# UNITED STATES PATENT AND TRADEMARK OFFICE

APPLICATION NO.	FILING DATE	FIRST NAMED INVENTOR	ATTORNEY DOCKET NO.	CONFIRMATION NO.
10/531,511	02/07/2006	Soichi Kuwahara	09792909-6161	9094

<b>Office Action Summary</b>	<b>Application No.</b> 10/531,511	<b>Applicant(s)</b> KUWAHARA ET AL.	
	<b>Examiner</b> John P. Zimmermann	<b>Art Unit</b> 2861

## **DETAILED ACTION**

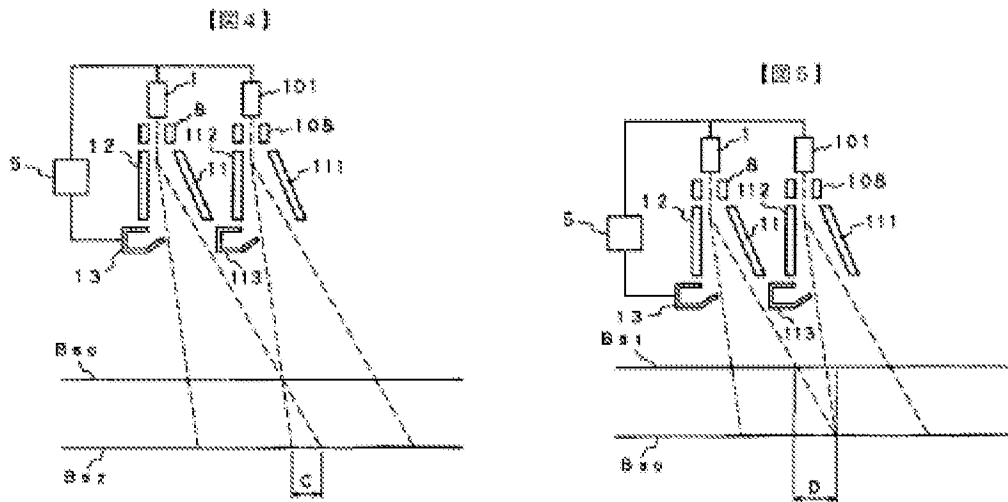
a. As related to independent **claim 1**, Yoshiyama et al. teach a liquid discharge apparatus comprising (Yoshiyama et al. – Abstract): a head in which a plurality of liquid discharge sections are arrayed (Yoshiyama et al. – Abstract; Machine Translation, Detailed Description, Paragraph 40; and Figure 4, Reference #1 & #101, shown below) and a discharge direction deflection unit configured to deflect a liquid discharged from at least one nozzle in the direction of the array of said liquid discharge sections (Yoshiyama et al. – Abstract; Machine Translation, Detailed Description, Paragraph 14; and Figures 4-5, Reference #11, #12, #111, & #112, shown below).

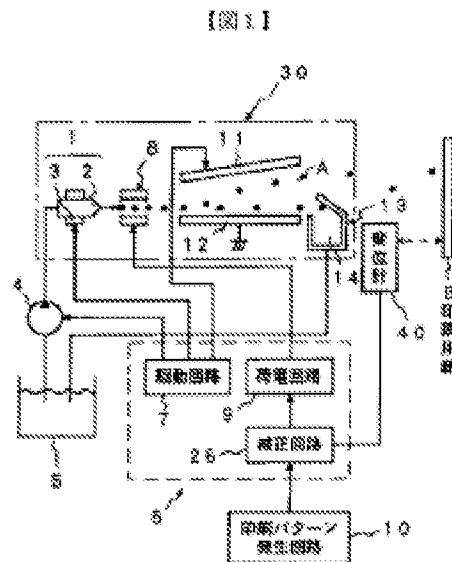
- b. Continuing with **claim 1**, Yoshiyama et al. teach a distance detection unit [i.e. laser displacement gage] to detect the distance between a liquid discharge surface of said head and a liquid landing surface of a liquid discharge target (Yoshiyama et al. – Abstract; Machine Translation, Detailed Description, Paragraph 18; and Figure 1, Reference #40, shown below) and a discharge deflection amount determination unit configured to determine the amount of liquid discharge deflection required by said discharge direction deflection unit as detected by said distance detection unit (Yoshiyama et al. – Abstract; Machine Translation, Detailed Description, Paragraphs 12 & 20; and Figure 1, Reference #6, #9, #30 & #40, shown below).

Nakano - Drawing 19

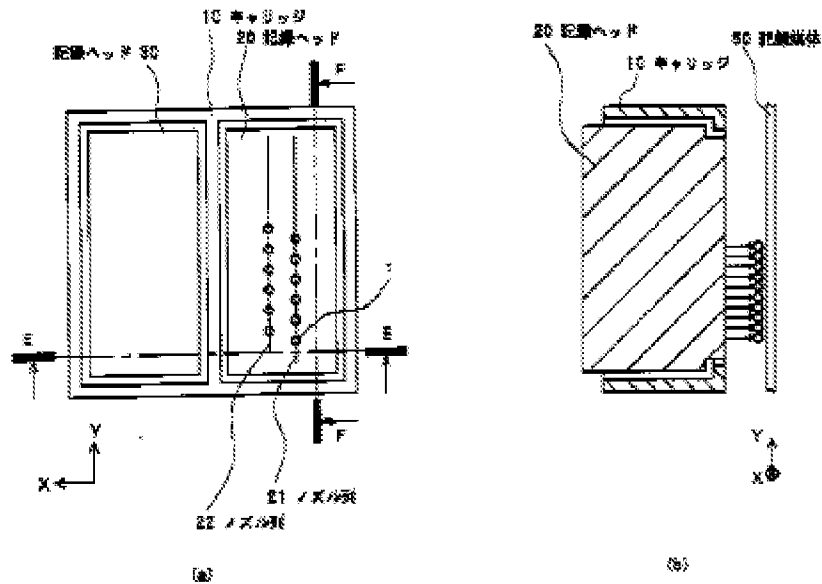
**However**, Nakano teaches an ink-jet recorder with an ink jet cartridge an ink jet head and a plurality of ink jet nozzles to include a plurality of nozzles arrayed in each of the liquid discharge sections (Nakano – Title; Abstract; Machine Translation, Detailed Description, Paragraph 85; and Drawings 19a-19b, Reference #t, #20, & #30, shown below).

Nakano -  
Drawing 20

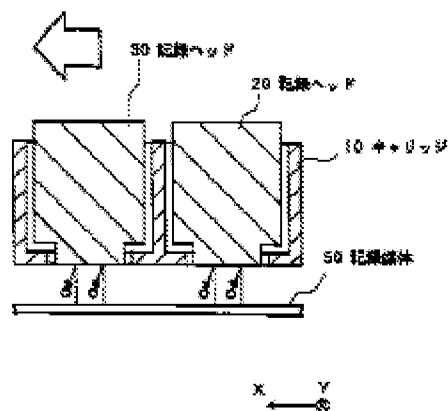
d. Continuing with **claim 1**, Nakano teaches a liquid chamber [i.e. ink container] in each of the liquid discharge sections and the liquid chamber is effective to contain the liquid to be discharged (Nakano – Abstract; Machine Translation, Detailed Description, Paragraph 85; and Drawing 20, Reference #20 & #30, shown below).

Nakano - Drawing 1 [ 1 ]

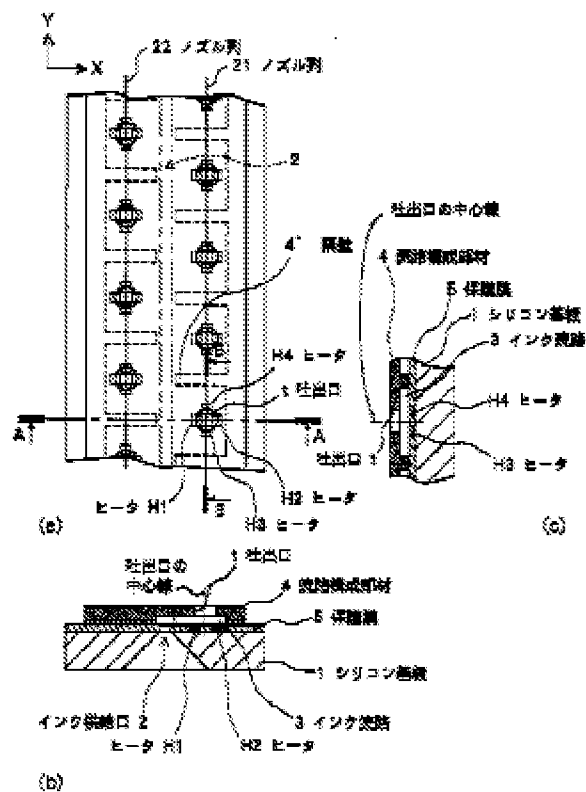
e. Continuing with **claim 1**, Nakano teaches a plurality [i.e. two or more] of heat generation units arrayed in the direction of the liquid discharge section array within the liquid chamber (Nakano – Abstract; Machine Translation, Detailed Description, Paragraphs 15-17; and Drawings 1a-1c, Reference #H1 - #H4, shown below).

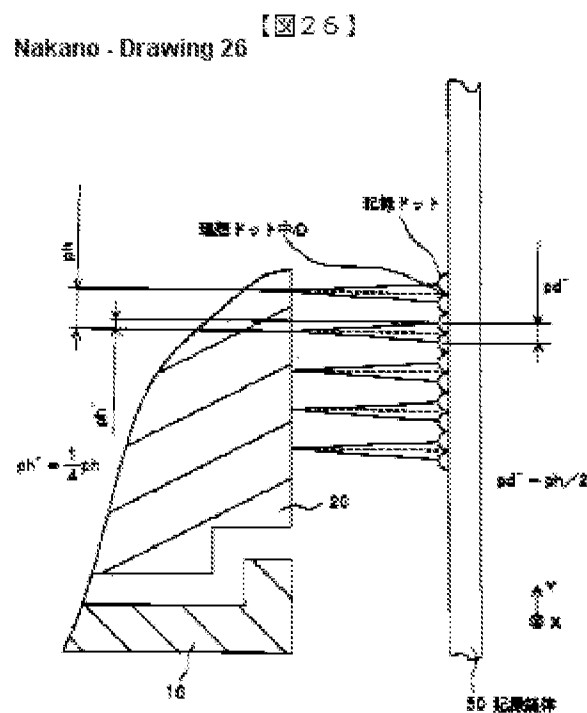
f. Continuing with **claim 1**, Nakano teaches at least two heat generation units are positioned within said liquid chamber such that the heat generation units [i.e. heaters] generate heat effective to cause the liquid to discharge from at least one of the plurality of said nozzles, and said discharge direction deflection unit generates a heat timing differential between two of said plurality of heat generation units which is effective to

deflect the direction [i.e. control the direction in one dimension (X or Y) or two dimensions (X & Y)] of a liquid discharged from one of the plurality of said nozzles (Nakano – Abstract; Machine Translation, Detailed Description, Paragraphs 15-17, 21, 25, 26, & 73-74; and Drawings 19a-19b, Reference Arrows, shown above; and Drawing 26, Reference Ink Deflection Directions, shown below).
